Replace Statutory Plate

Classification Campaign Bulletin **Section/Group** 19 - Labels **Country/Region** EMEA

Year 2019 **Model** Model 3 **Version** LHD

Figure 2

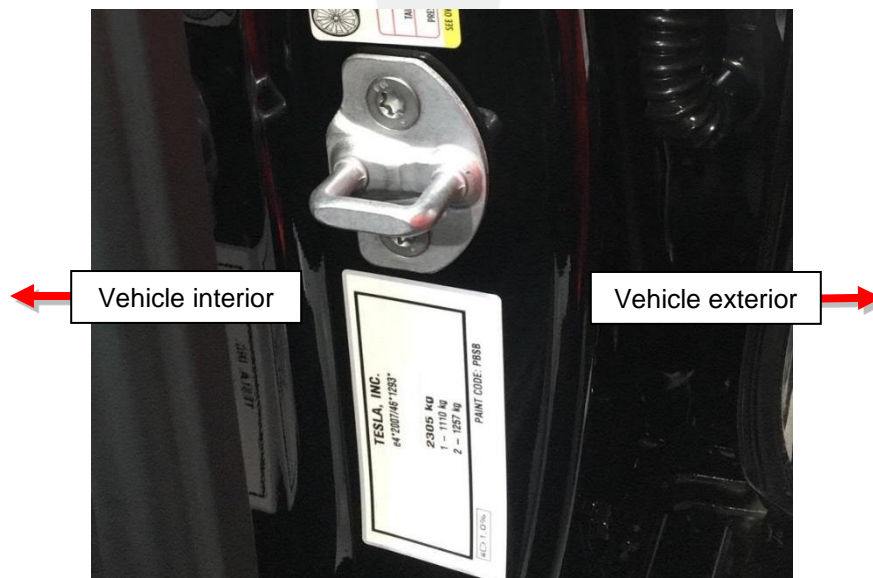
5. Use an alcohol wipe to remove any remaining adhesive or statutory plate shreds. Allow the alcohol to completely dry before continuing.
6. Install the updated statutory plate in the same location.

NOTE: Position the statutory plate so that it is readable when standing outside of the vehicle (Figure 2).
